## PIC12F629/675 Rev. A Silicon/Data Sheet Errata

The PIC12F629/675 parts you have received conform functionally to the Device Data Sheet (DS41190C), except for the anomalies described below.

## REGISTER 3-2: TRISIO – GPIO TRI-STATE REGISTER (ADDRESS: 85h)

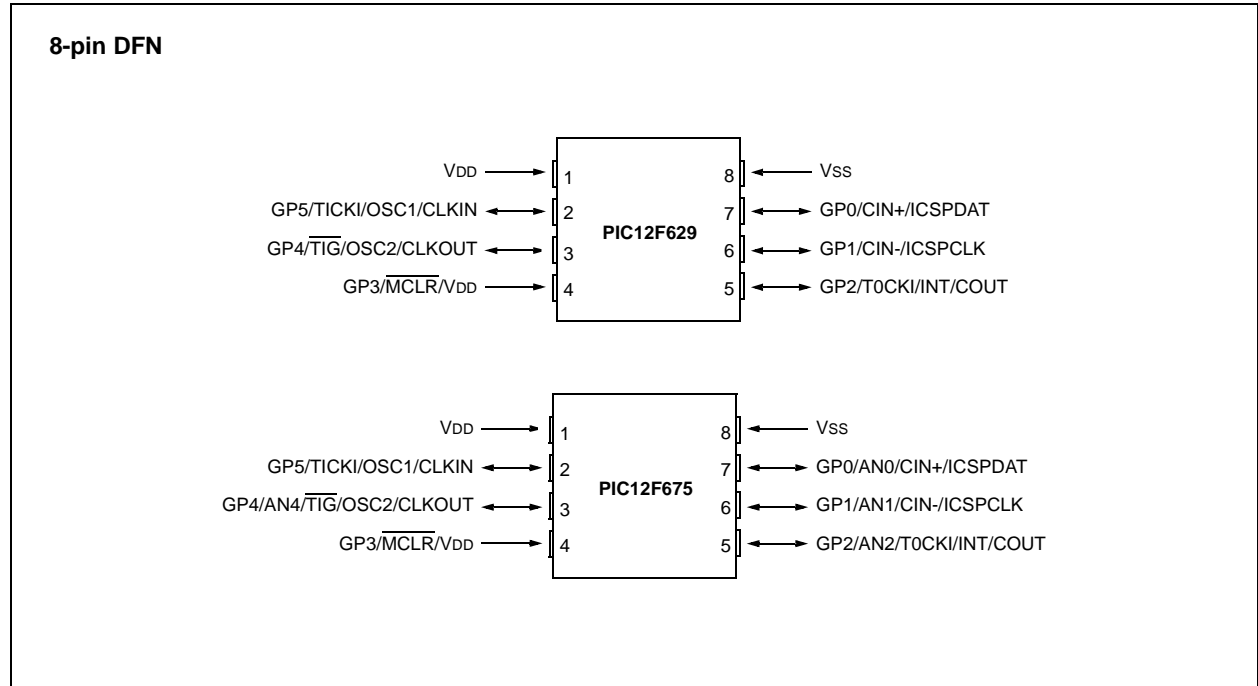
Register 3-2, "TRISIO – GPIO Tri-state Register (Address: 85h)", is incorrect. Bits 5-4 and 2-0 should read "R/W-1", as shown below:

U-0	U-0	R/W-1	R/W-1	R-1	R/W-1	R/W-1	R/W-1	
—	—	TRISIO5	TRISIO4	TRISIO3 <sup>(1)</sup>	TRISIO2	TRISIO1	TRISIO0	
bit 7								bit 0

## 8-Lead Plastic Dual Flat No Lead Package (ML) 4x4x1 mm Body (DFN) – Saw Singulated

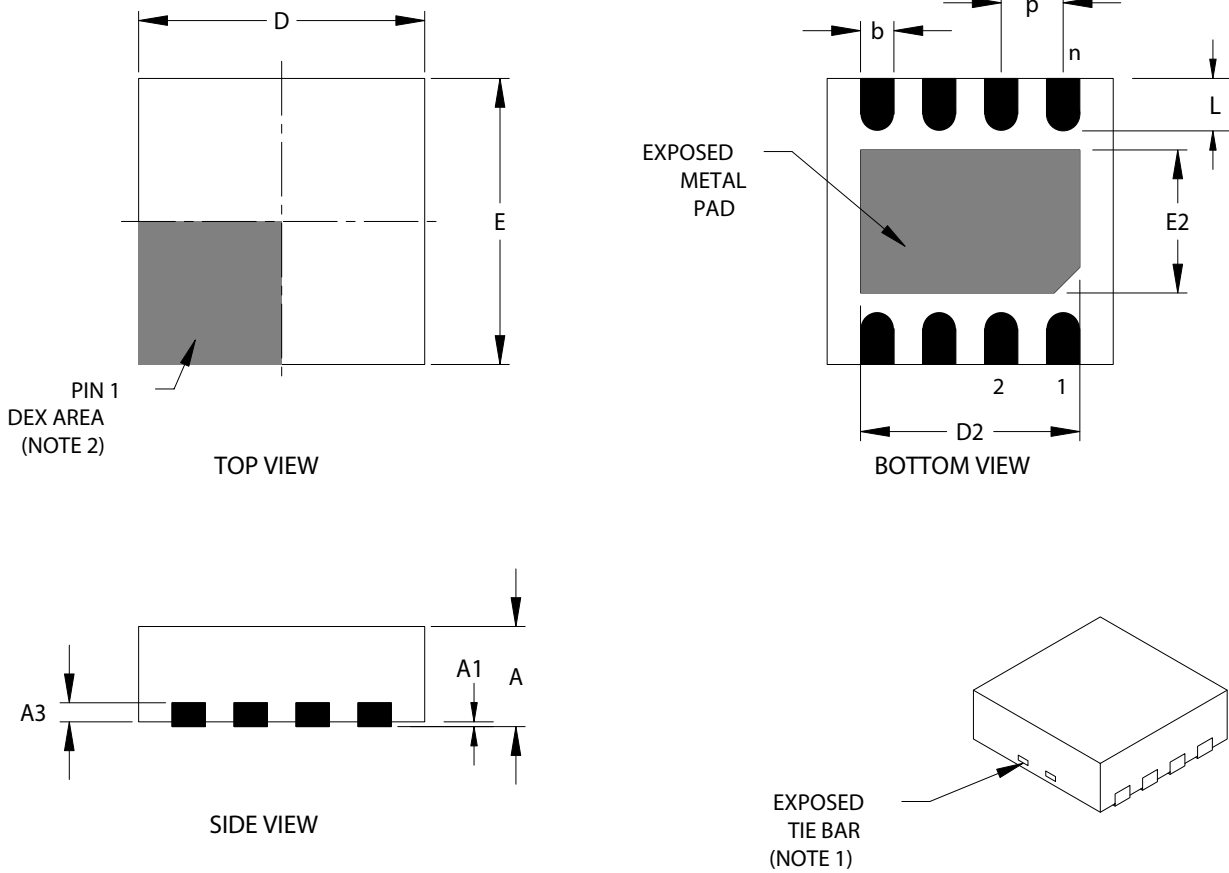
## 2. Module: New 4x4 DFN Package Added

The new 8-pin 4x4 DFN pinout diagram will be added to the Pin Diagrams figure on page 2 and the Packaging Information chapter as shown below:
